ATTACHMENT I

ST. LUCIE UNIT 1

TECHNICAL SPECIFICATIONS

FOR F_{xy}^T DELETION

FIGURE 3.2-3
Allowable Combinations Of Thermal Power And F_T^T

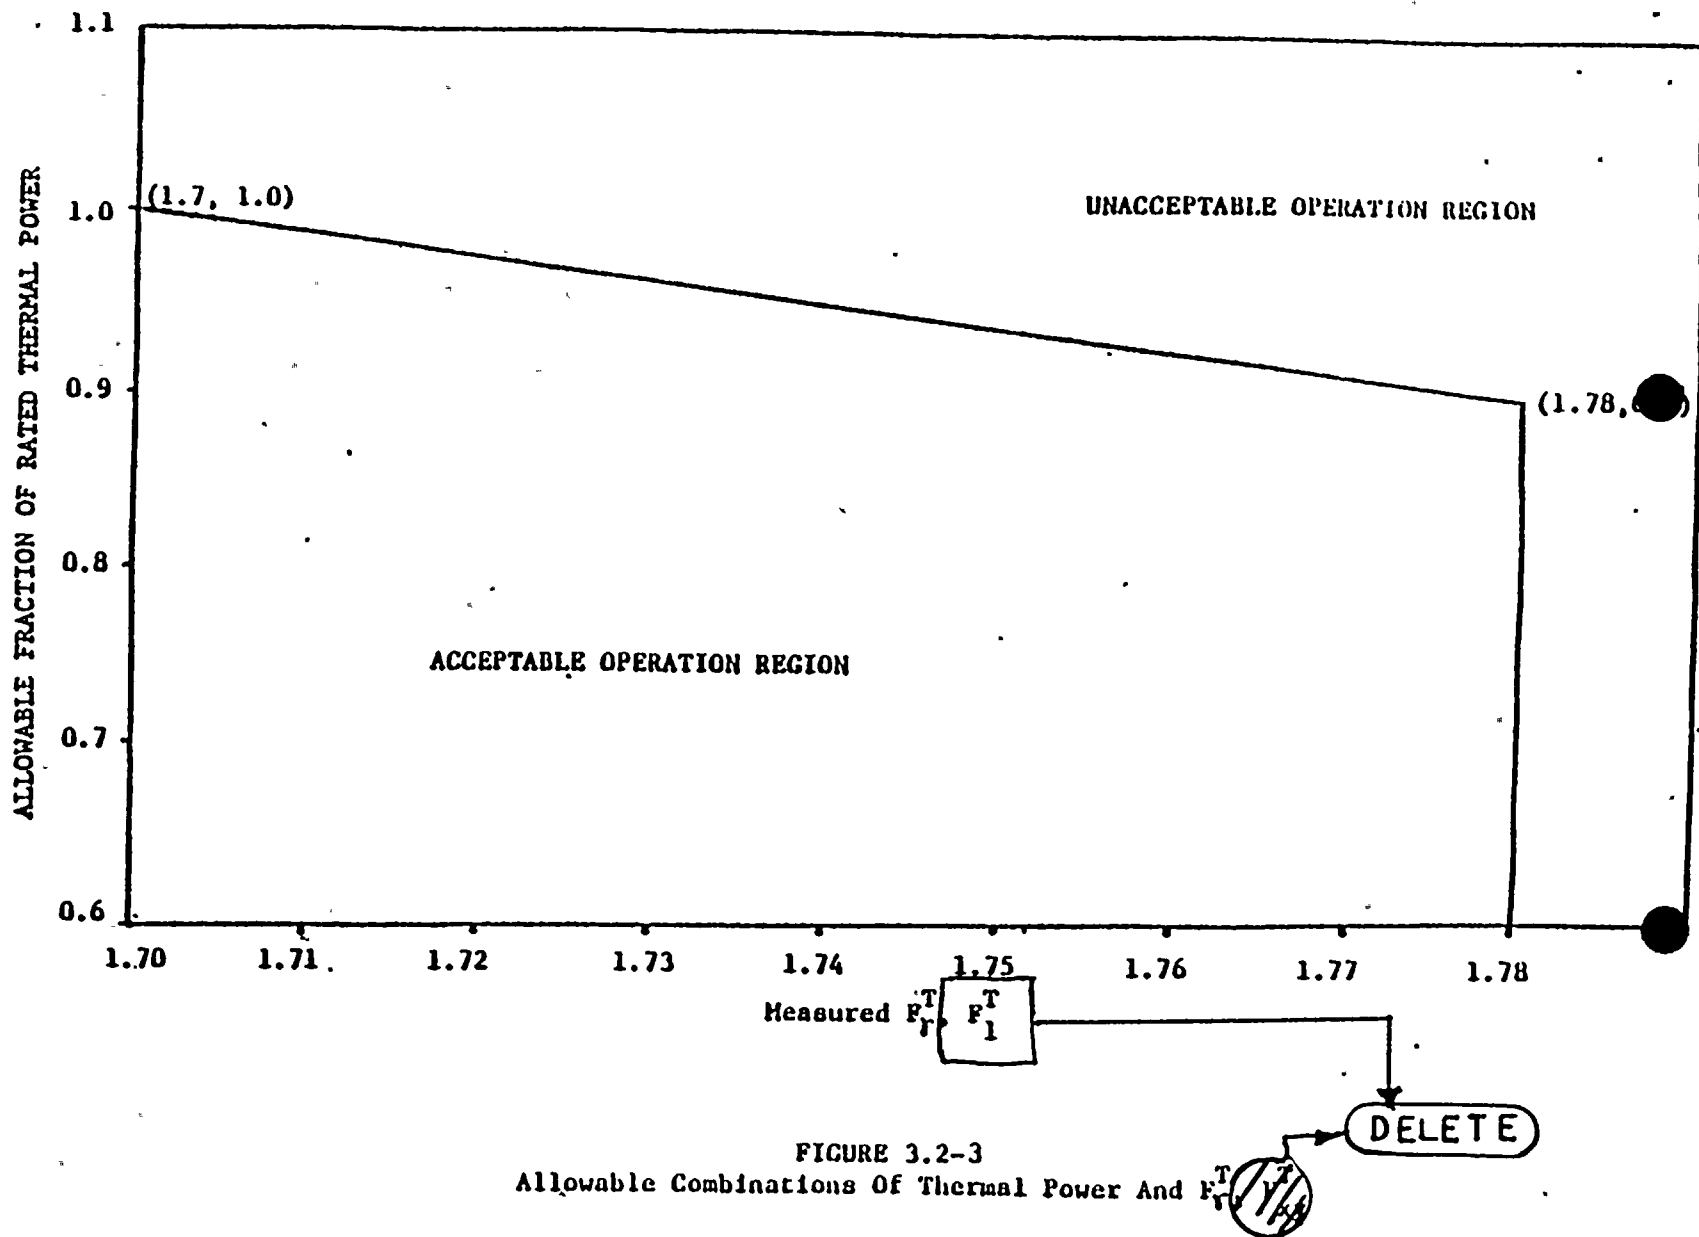
Action: Reference to " F_{xy}^T " is deleted from Figure 3.2-3. Additionally the term " F_1^T " is deleted.

Discussion: The deletion of the " F_{xy}^T " term from Figure 3.2-3 is needed due to the deletion of Technical Specification 3/4.2.2 (which defines the limits of the peaking factor - F_{xy}^T). The term " F_1^T " in the title "Measured F_r^T, F_l^T " is a typographical error. The term should have been " F_{xy}^T " which is being deleted.
